SUBJECT: Forwards rev to facility position re seismic design of category I structures.

BELLEVILLE NUCLEAR PLANT (BLN) - TRANSMITTAL OF REVISION TO TVA POSITION
REGARDING SEISMIC DESIGN OF CATEGORY I STRUCTURES (TAC #79276)

BELLEFONTE POSITION PAPER REGARDING SEISMIC DESIGN OF CATEGORY I STRUCTURES

Figure 3.
INTERIOR CONCRETE

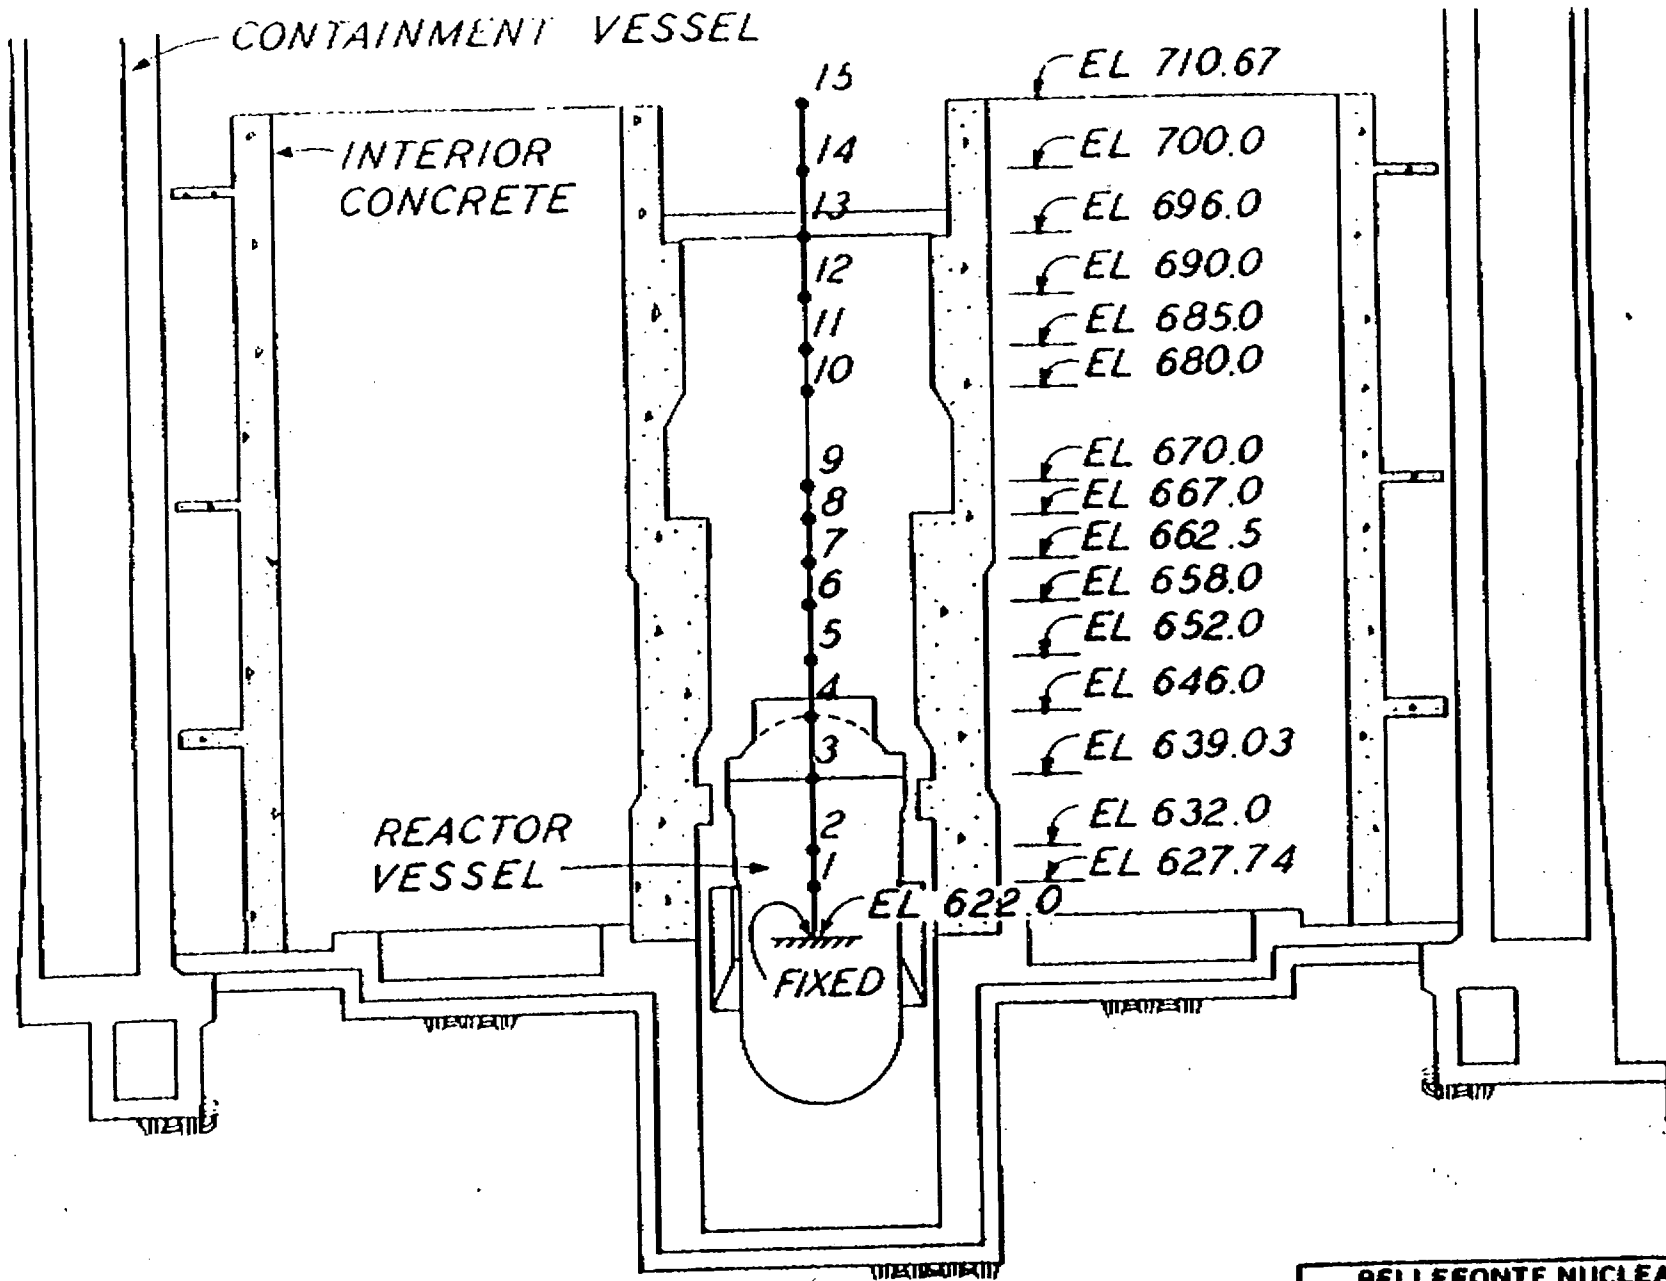
4. NSSS-structure interaction.	The mass and stiffness of the NSSS equipment was not explicitly included in the seismic model of the interior concrete structure. This could possibly affect the calculated response of the NSSS.

4 - Nuclear Steam Supply System (NSSS) - Structure Interaction The Reactor Building seismic model (in particular the interior concrete structure) will be revised to include simplified models (mass and stiffness) of the major NSSS equipment.

Figure 4
AUXILIARY-CONTROL BUILDING

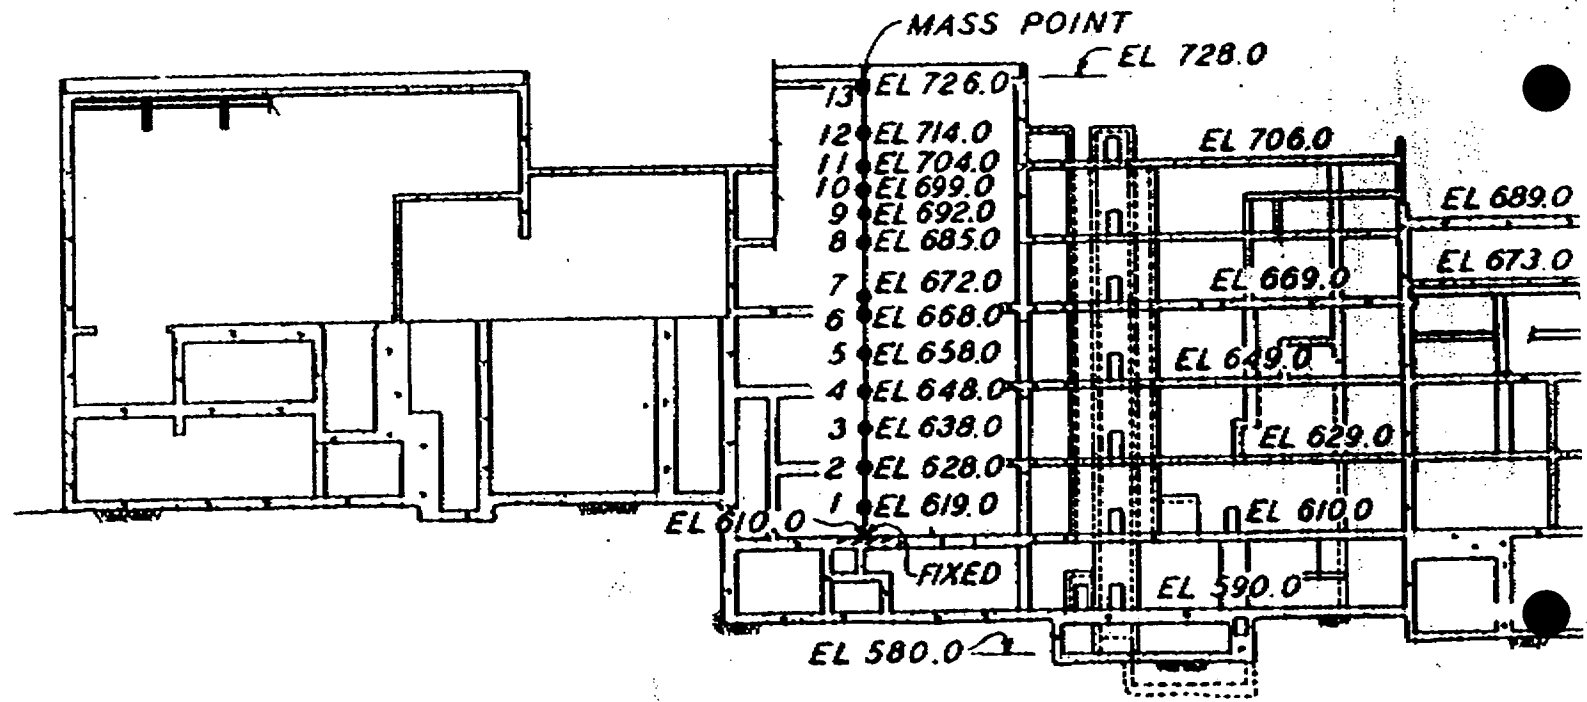
Auxiliary-Control Building The Auxiliary-Control Building is a reinforced concrete structure common to both units (Figure 4). The Auxiliary-Control Building is supported on bedrock at elevation 615 ft.

Figure 7
INTAKE PUMPING STATION

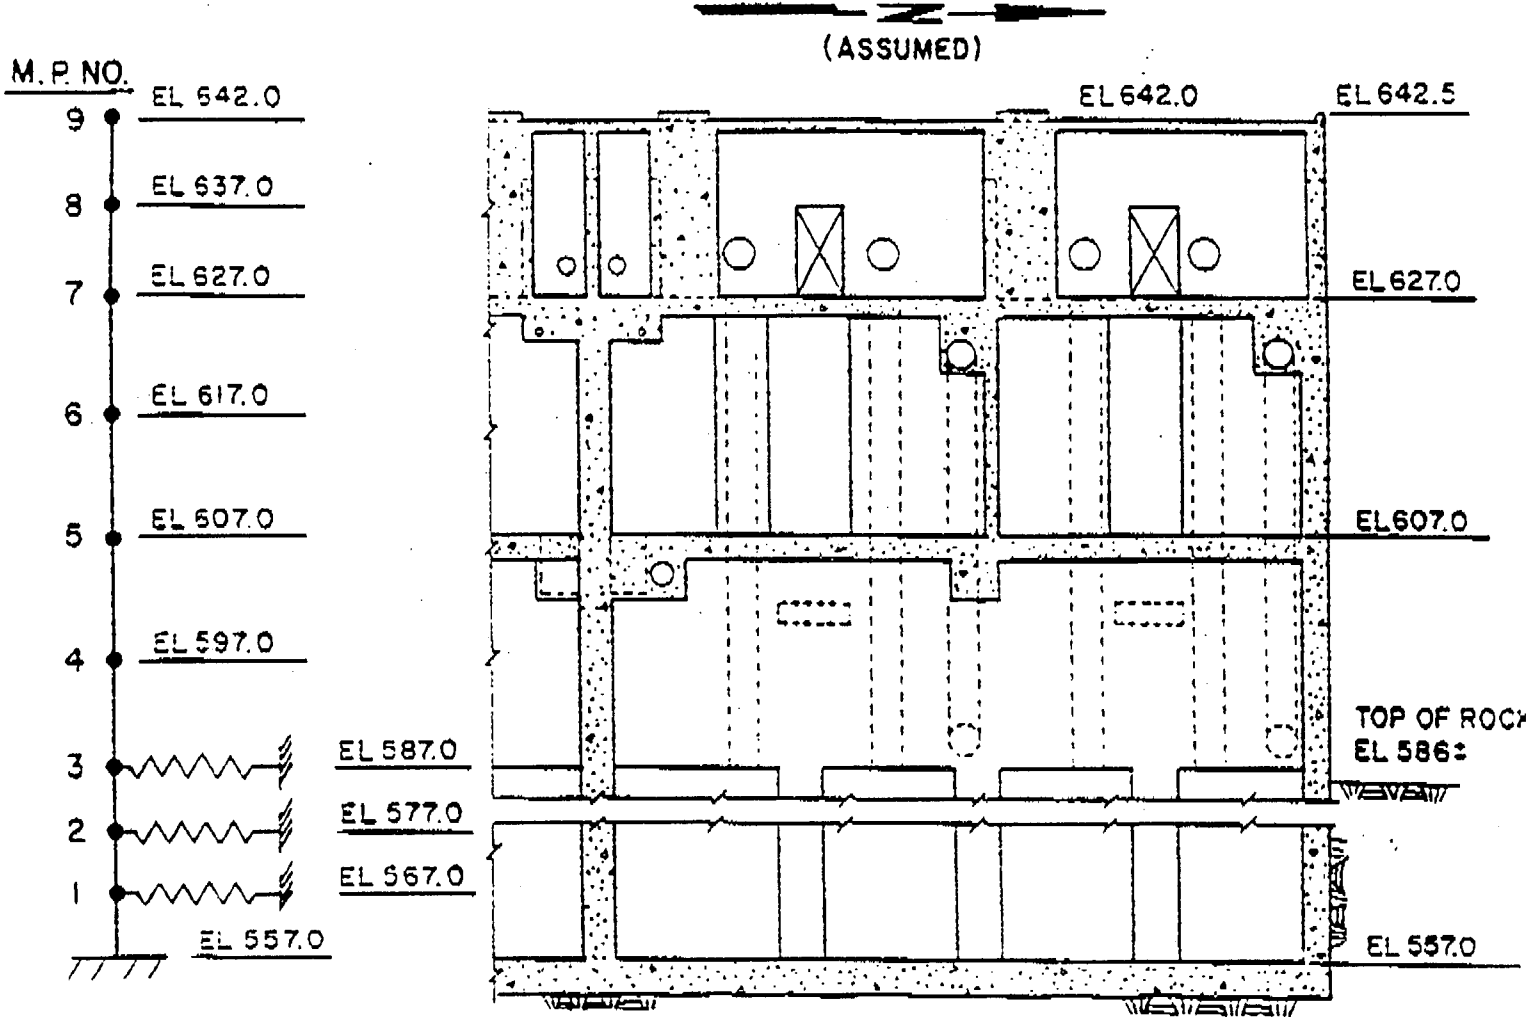
Intake Pumping Station The Intake Pumping Station is a cellular box-type reinforced concrete structure common to both units (Figure 7). The structure is embedded into rock on the north and south sides up to elevation 580 ft. The west side is backfilled with granular soil up to elevation 600 ft. The east side is the intake side.
